Manual Supplement

Manual Title: 753/754 Users
Print Date: July 2011
Revision/Date: 1, 8/12

Supplement Issue: **6**
Issue Date: 10/19
Page Count: 6

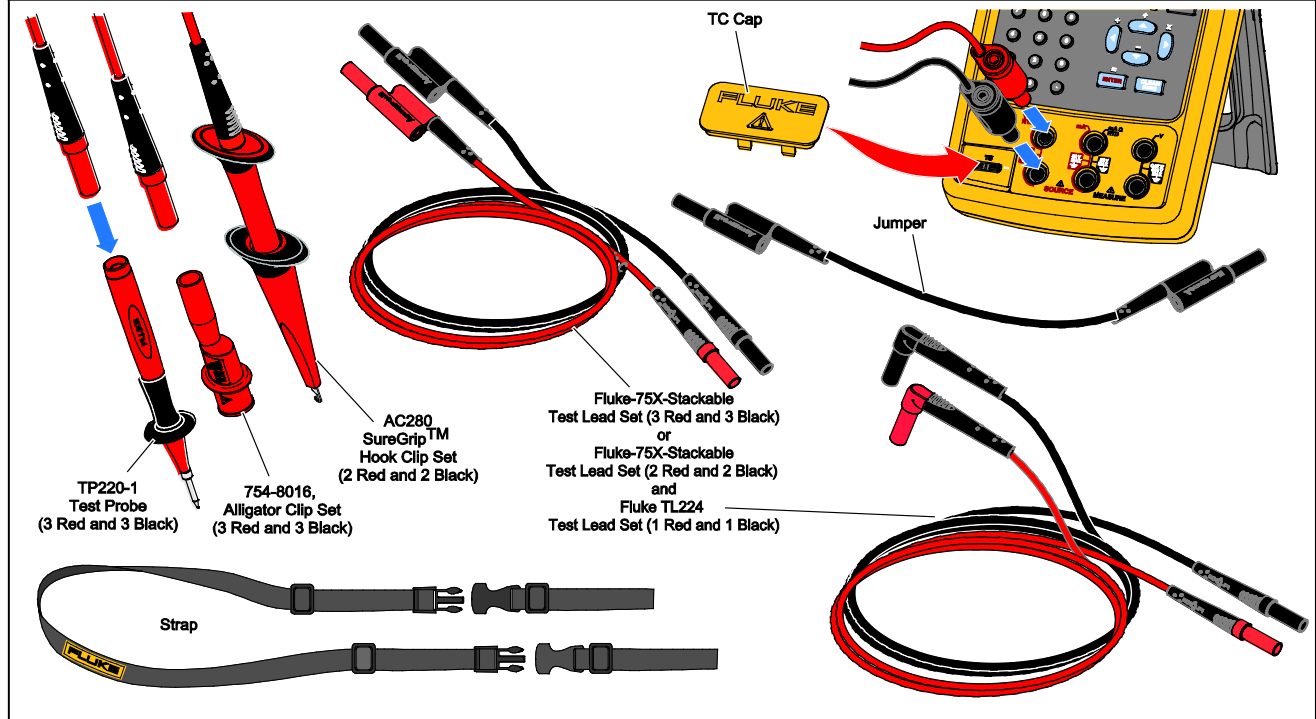
On the Cover add the  **Symbol**.

On page 5, add the following to the **Symbols** table:

<p>Conforms to the Appliance Efficiency Regulation (California Code of Regulations, Title 20, Sections 1601 through 1608), for small battery charging systems.</p>
---	--
